RE-BID ADDENDUM ONE

Project: **Sullivan County Schools East High School S.T.E.M. Classroom Renovations
RE-BID**

January 29, 2024

S-11

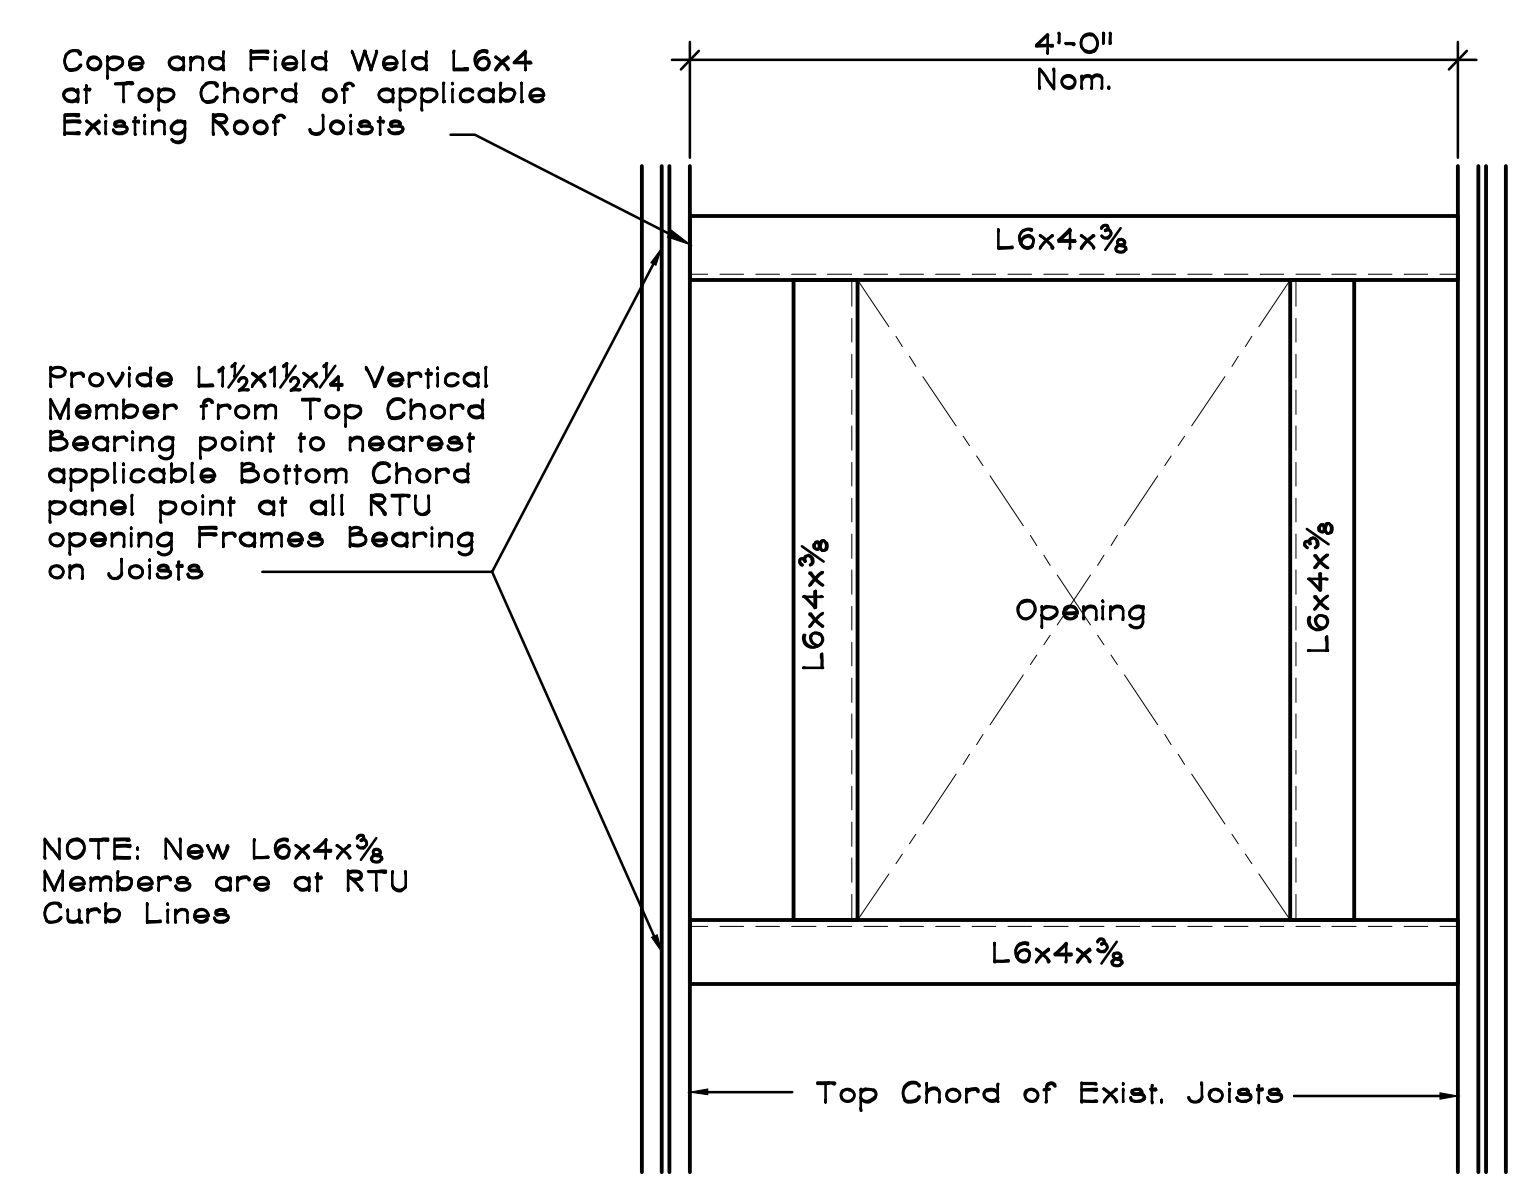
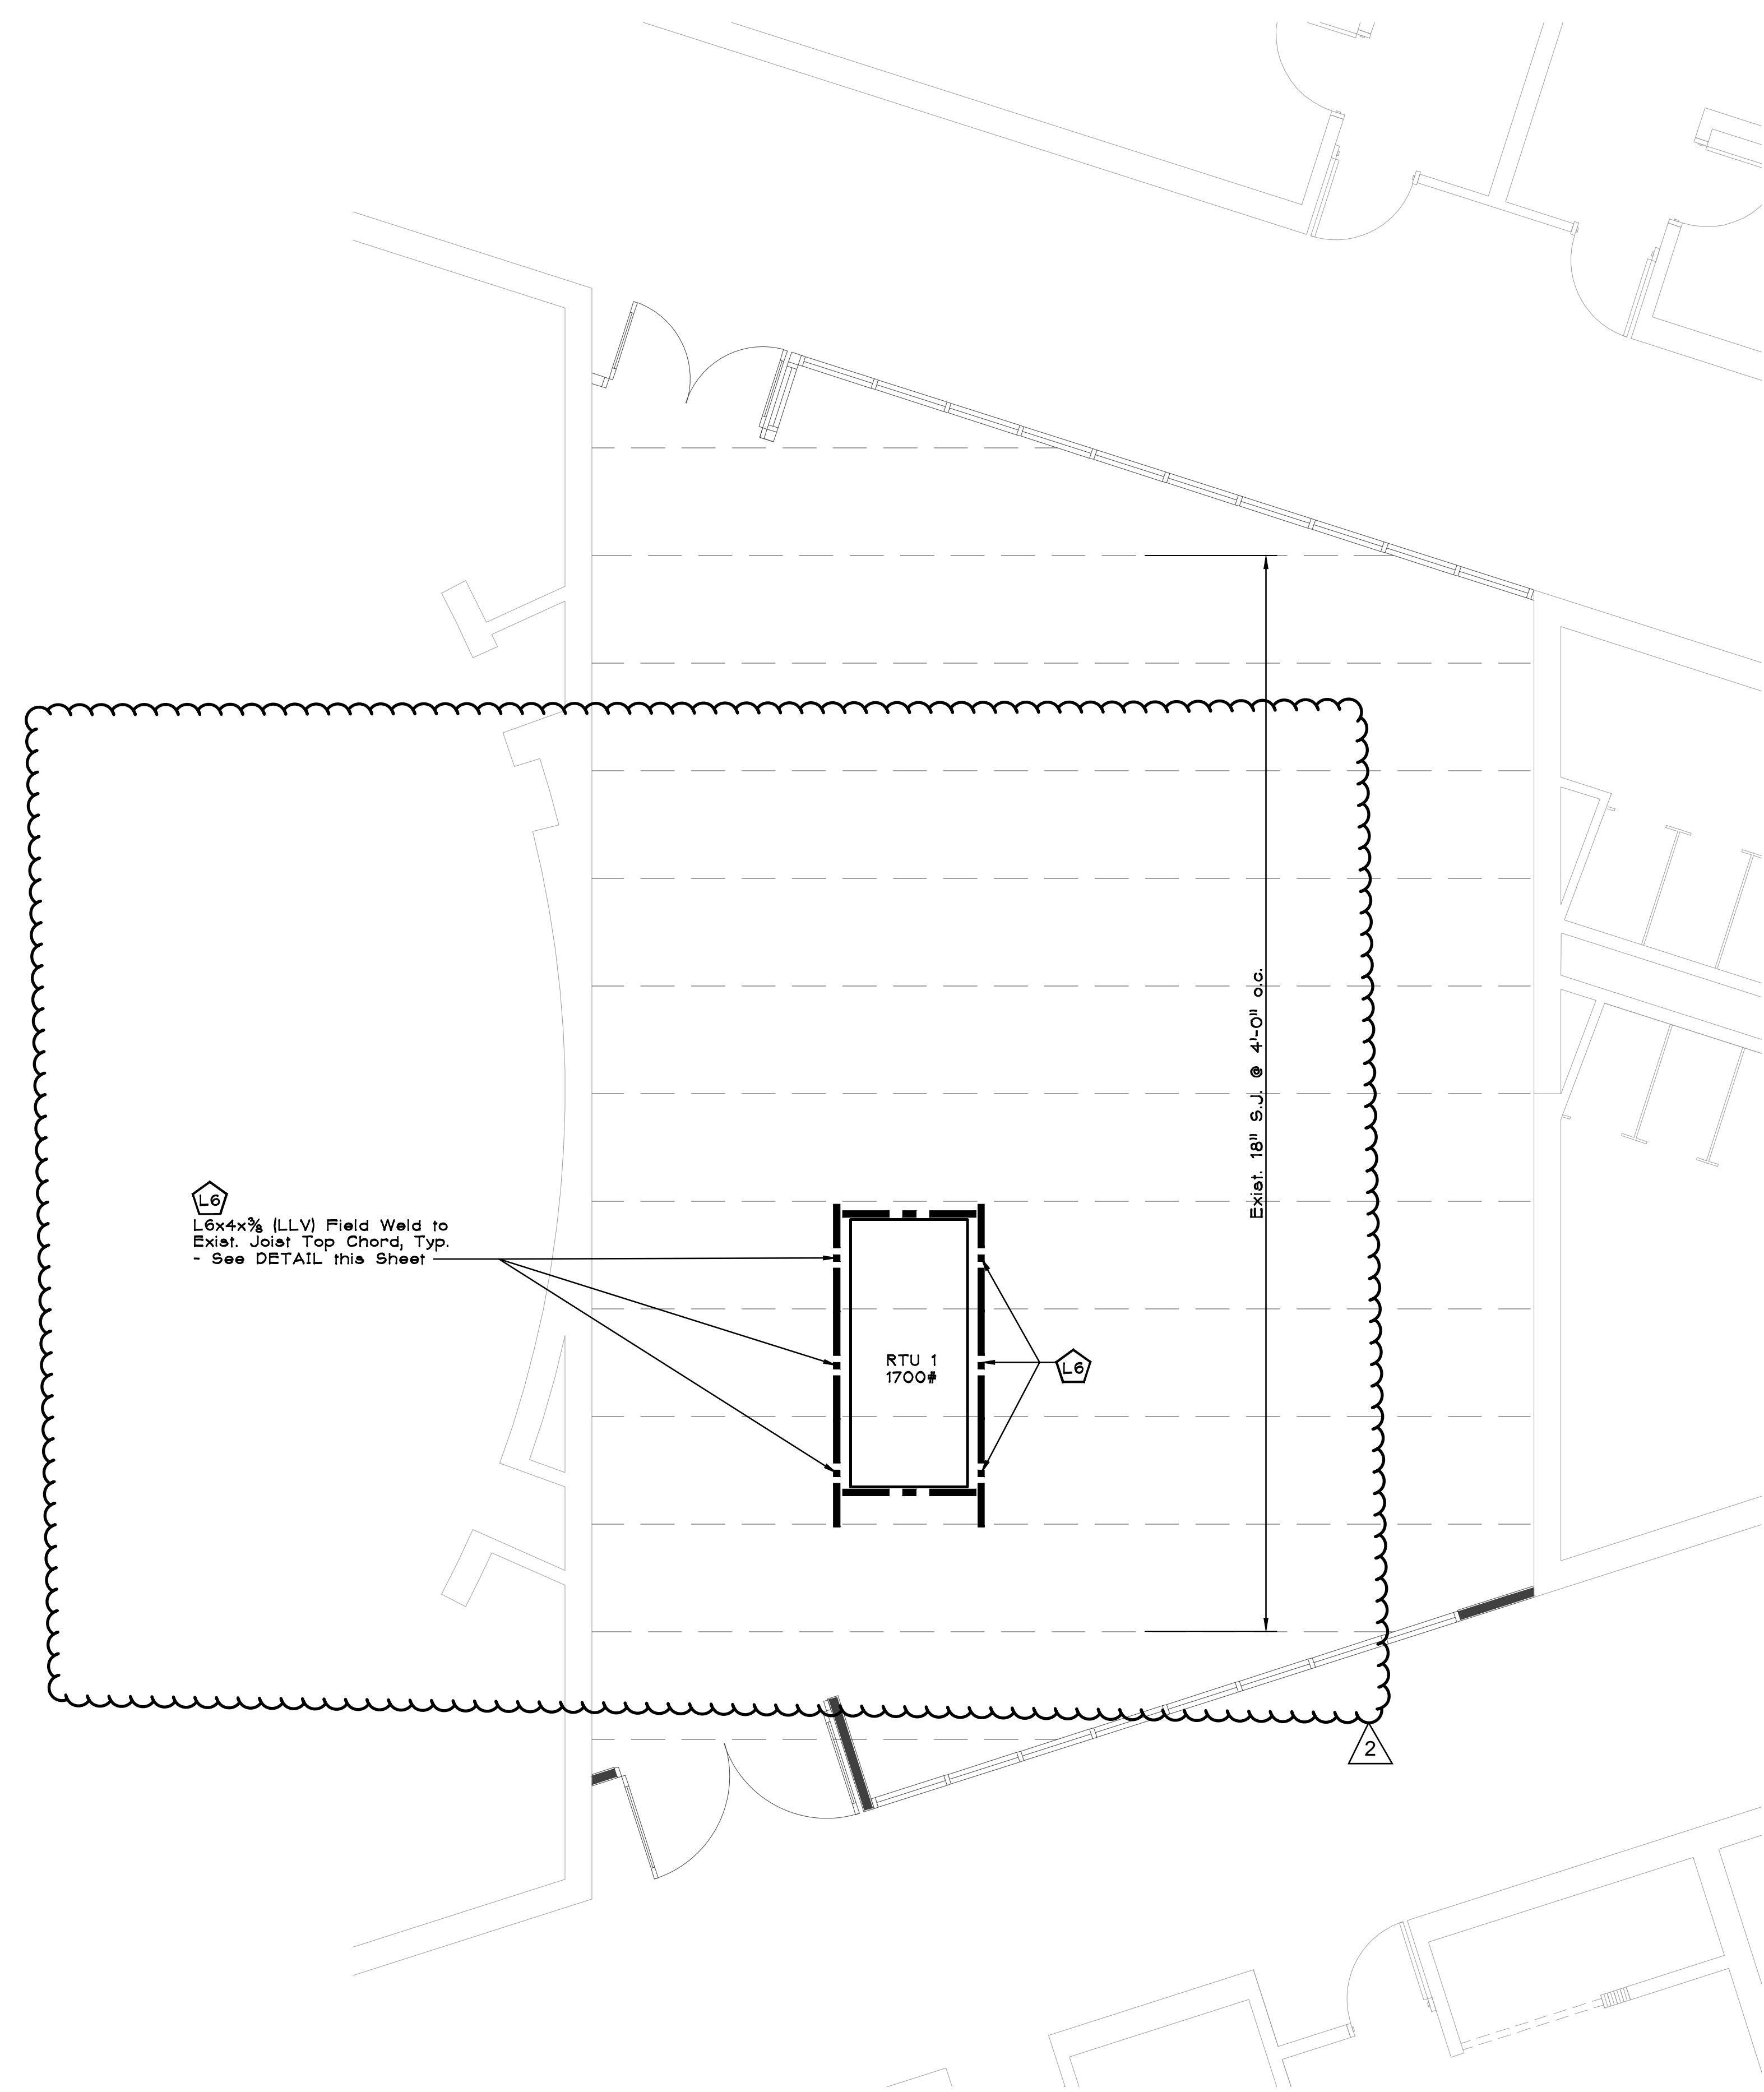
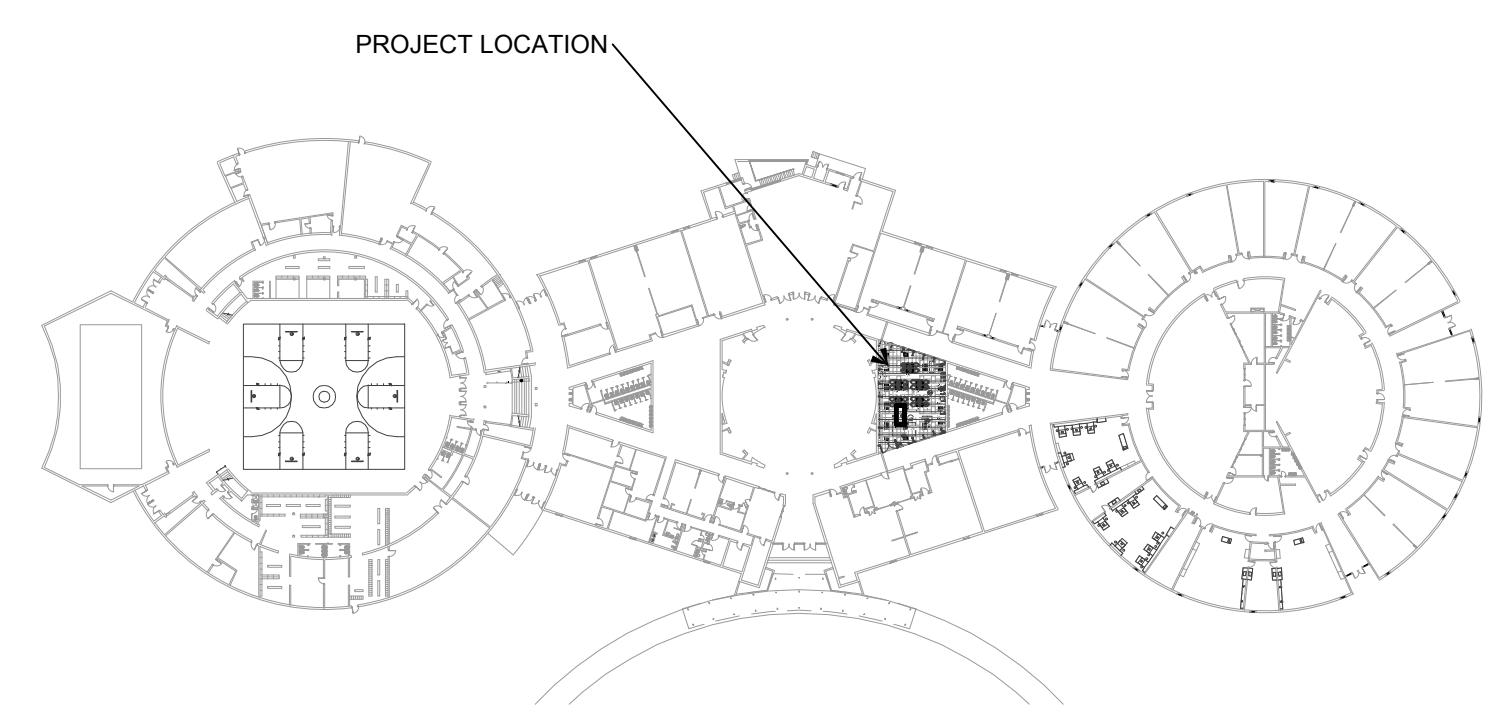
- a. **DRAWING G-00** – Issued Date
- b. **DRAWING G-00** – Drawing Index updated
- c. **DRAWING G-00** – Architect and Engineer Seals Updated
- d. **DRAWING G-01** – Revised Bid Alternates
- e. **DRAWING S-11** – Revised Structural to reflect a single rooftop HVAC unit
- f. **DRAWING A-10** – Revisions: Key Notes, Wall Construction for back corridor wall, Alternate #3 borrowed lites
- g. **DRAWING A-20** – Revisions: Key Notes, Interior Elevations
- h. **DRAWING I-10** – Revisions: Key Notes, lighting layout
- i. **DRAWING MP-1.0** – Revisions: RTU Schedule
- j. **DRAWING MP-1.1** – Revisions: HVAC System & Ductwork layout
- k. **DRAWING E-11** – Revisions to the lighting layout
- l. **DRAWING E-12** – Revisions to the HVAC power

NOTE: New L6x4x3/8 Members are at RTU Curb Lines
